Subject: AP1000 COL Response to Request for Additional Information (TR 29)

Westinghouse is submitting a revised response to the NRC request for additional information (RAI) on AP1000 Standard Combined License Technical Report (TR) 29, APP-GW-GLR-044, Nuclear Island Basemat and Foundation. This RAI response is submitted in support of the AP1000 Design Certification Amendment Application (Docket No. 52-006). The information included in the response is generic and is expected to apply to all COL applications referencing the AP1000 Design Certification and the AP1000 Design Certification Amendment Application.

RAI Response Number: RAI-TR29-SRSB-01
Revision: 1

Figure 6-34
DEDVI, ADS 1-3 Integrated Vapor Discharge

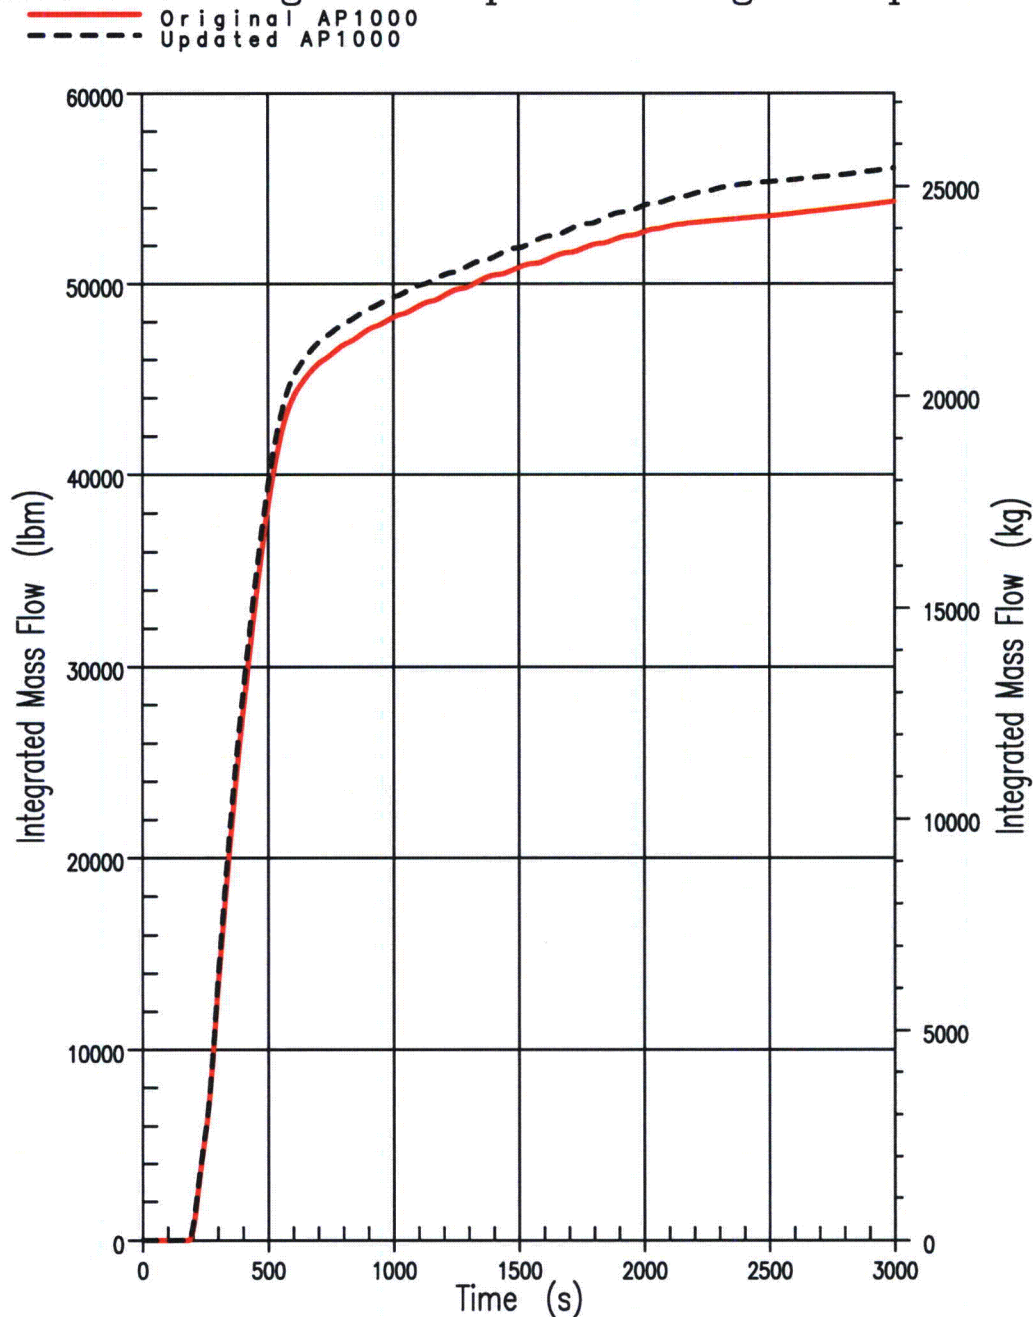
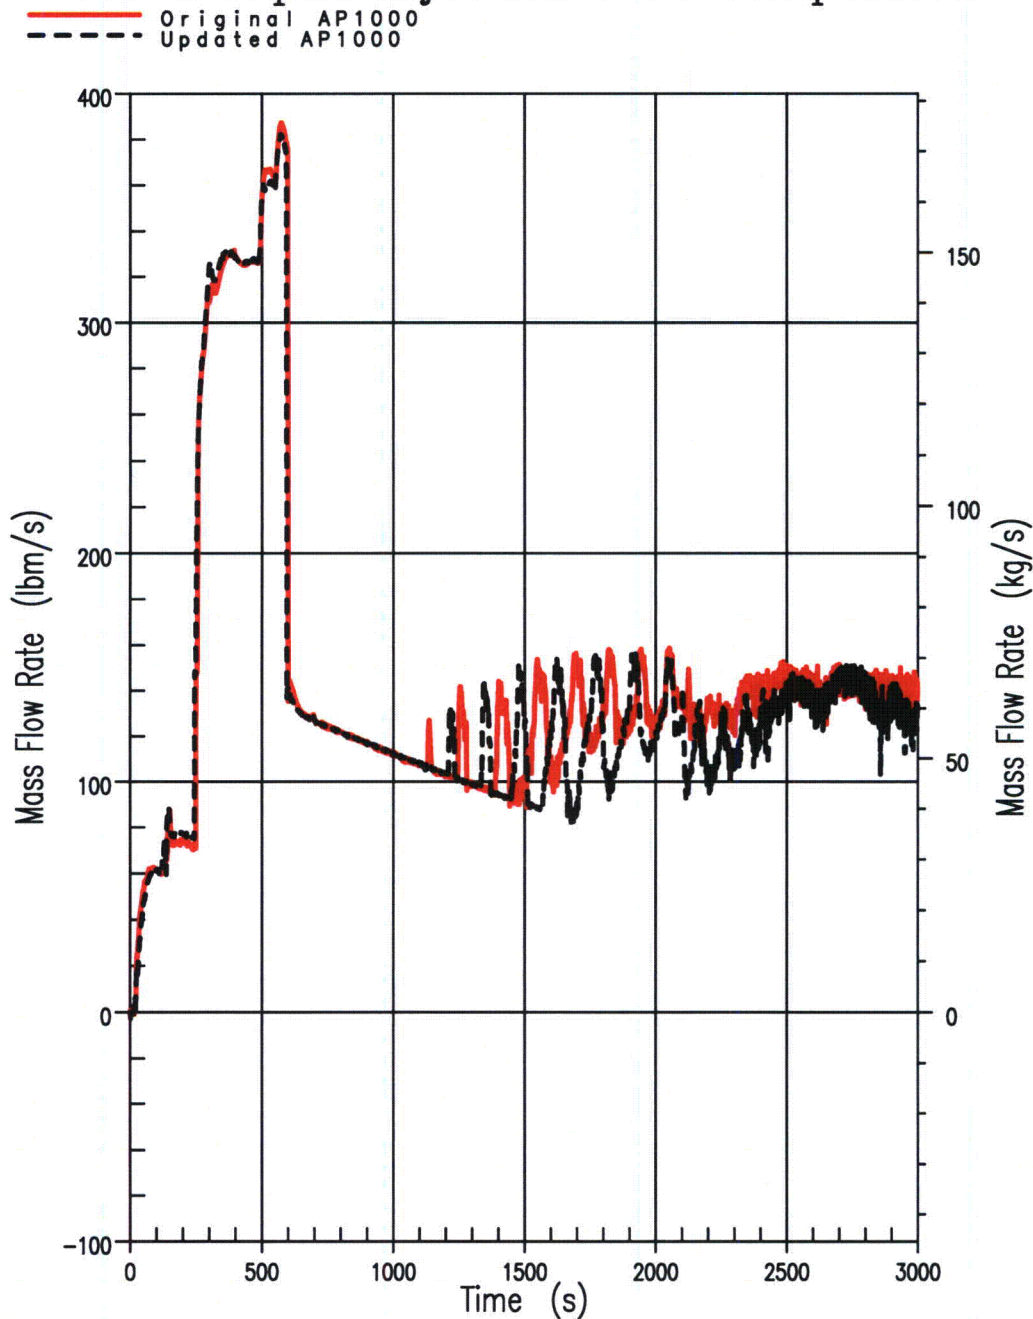
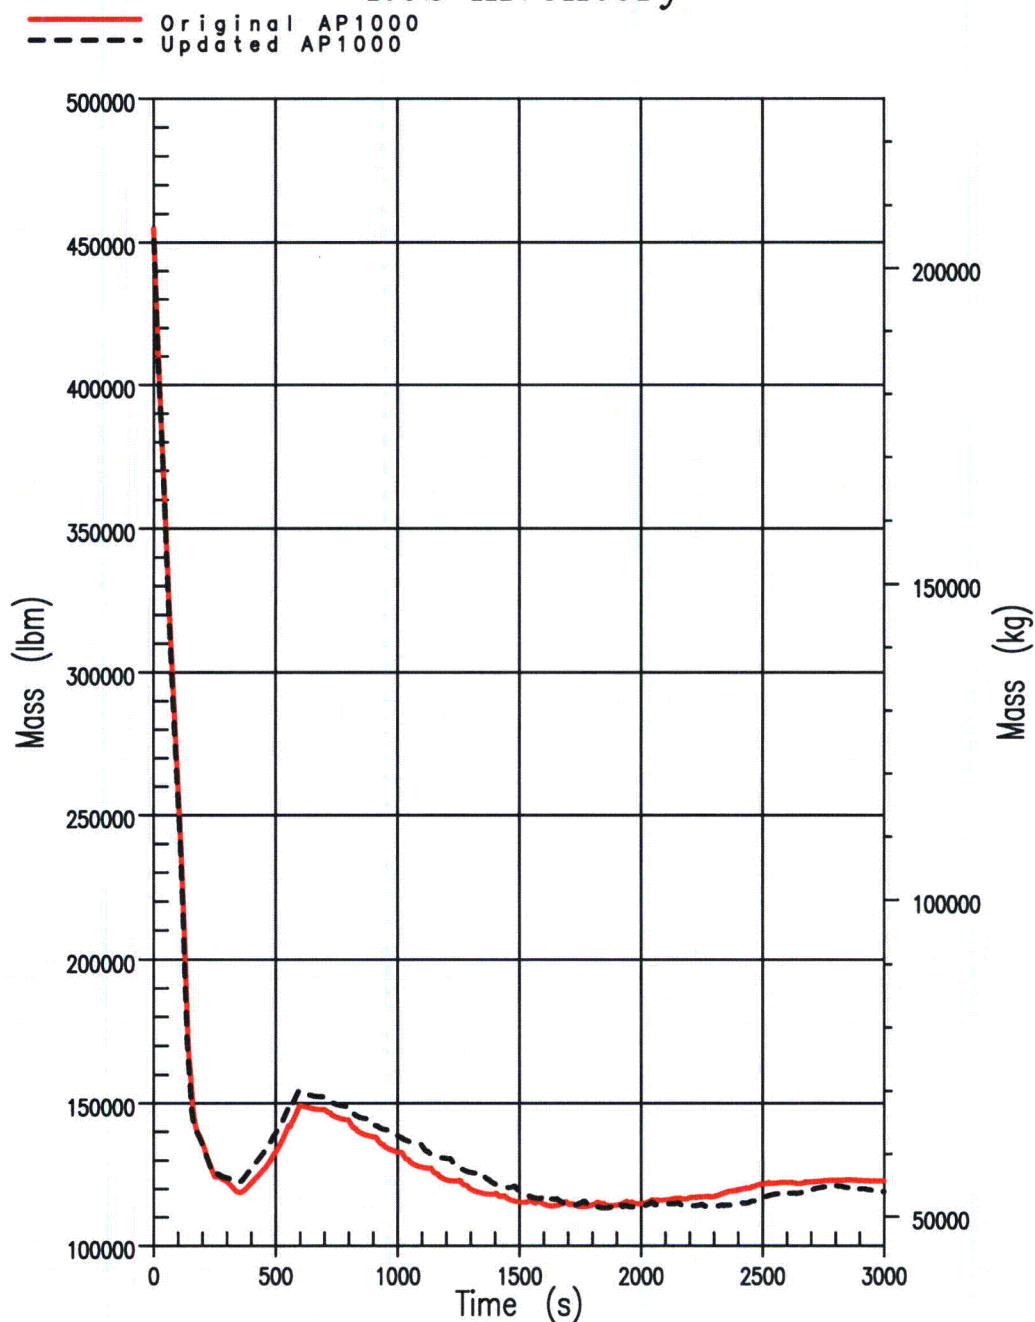
Please provide an evaluation of the impacts of these proposed changes on the analysis results of each of the transients and accidents in DCD Chapter 15. The evaluation should demonstrate either the analysis results of DCD Chapter 15, Revision 15, remain bounding and valid, or the effects of these changes are insignificantly small that the applicable acceptance criteria for these transients and accidents remain complied with.

Table 6-2 and Figures 6-28 through 6-36 present a comparison of the DEDVI line break cases. The results demonstrate the effect of the change in the reactor internals design (including the revised Pressurizer). For the DEDVI line break, the observed changes in response can be attributed primarily to the change in the Pressurizer rather than to the reactor internals changes. The largest observed changes are the decreases in both the Pressurizer Mixture Level (Figure 6-31) and Pressurizer Void Fraction (Figure 6-32). These subsequently reduce the Automatic Depressurization System (ADS) Stage 1-3 liquid discharge (Figure 6-33) and increase the ADS 1-3 vapor discharge (Figure 6-34). The overall effect is slightly larger Reactor Coolant System (RCS) inventory for a majority of the transient simulation period (Figure 6-36), with about the same predicted minimum RCS inventory. No significant changes in the RCS Pressure (Figures 6-28 and 6-29), Core Mixture Level (Figure 6-30), and DVI injection characteristics (Figure 6-35) are observed as a result of the design changes implemented.
